Form 3160-5
(August 2007)UNITED STATES
DEPARTMENT OF THE INTERIOR
BUREAU OF LAND MANAGEMENT

8. Well Name and No.
Spanky Federal Corn #1

Marbob Energy respectfully requests approval for the following location change:

PECOS DISTRICT CONDITIONS OF APPROVAL

Figure 1 – Cross Sections and Plans For Typical Road Sections

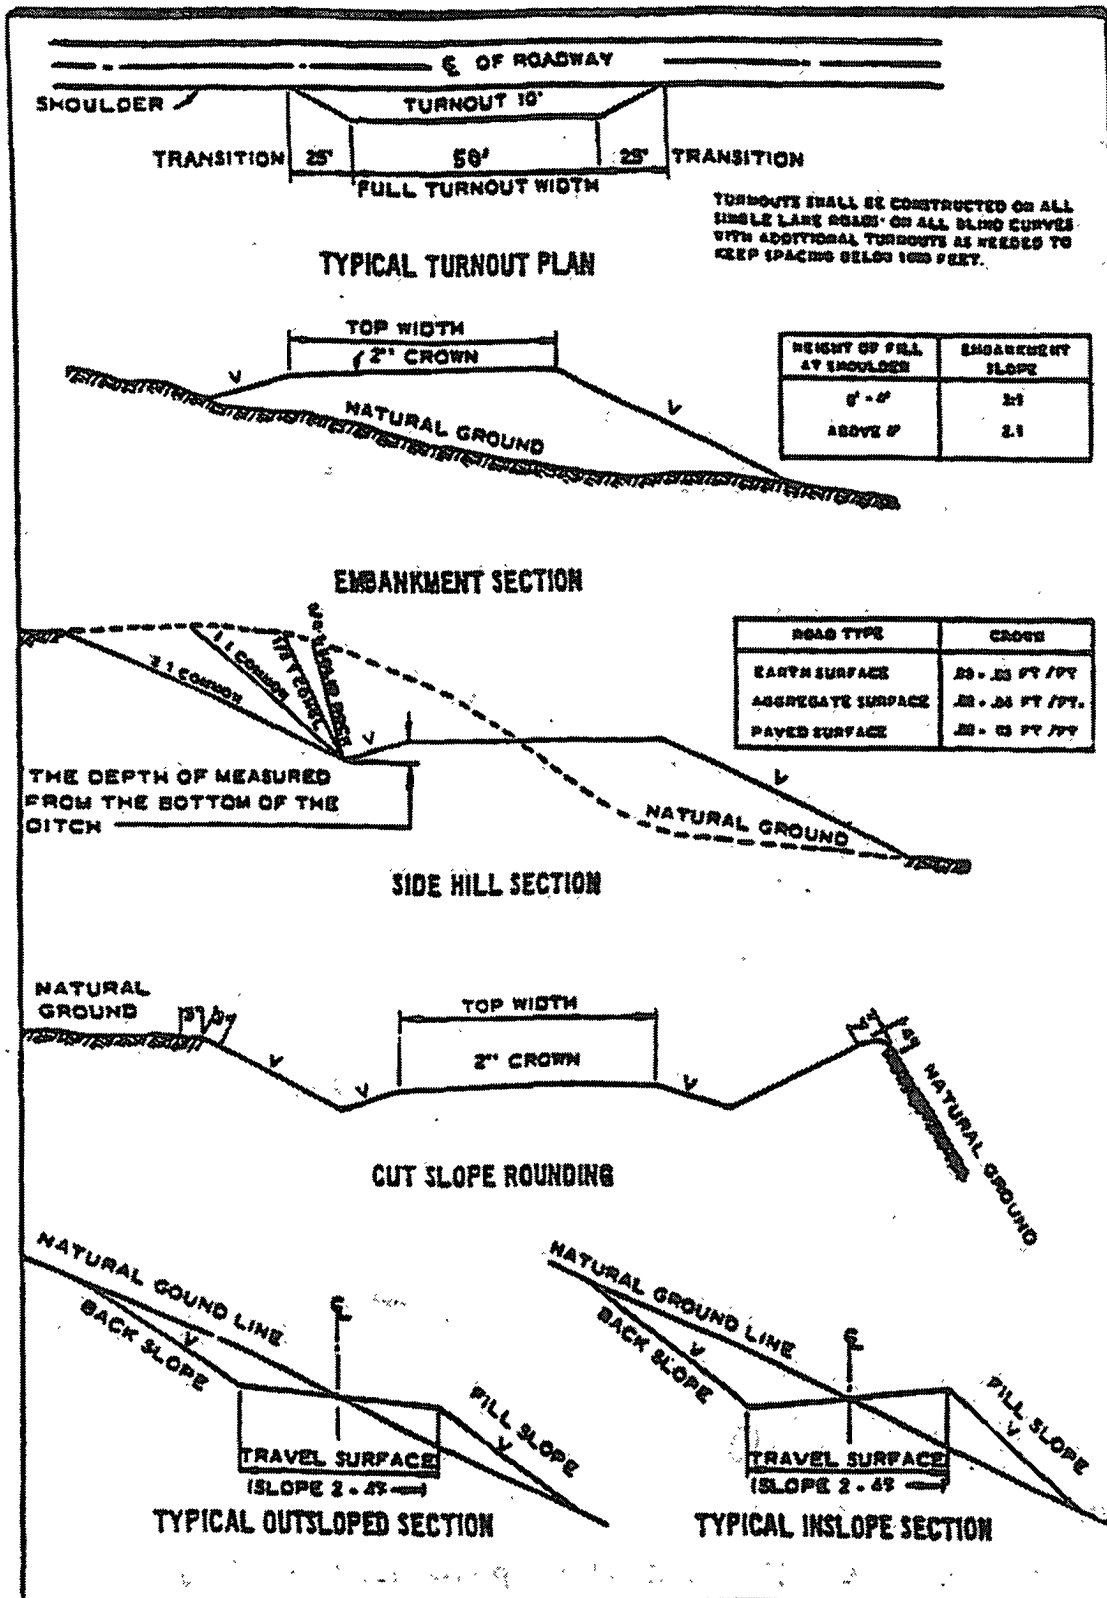
Crowning shall be done on the access road driving surface. The road crown shall have a grade of approximately 2% (i.e., a 1" crown on a 14' wide road). The road shall conform to Figure 1; cross section and plans for typical road construction.
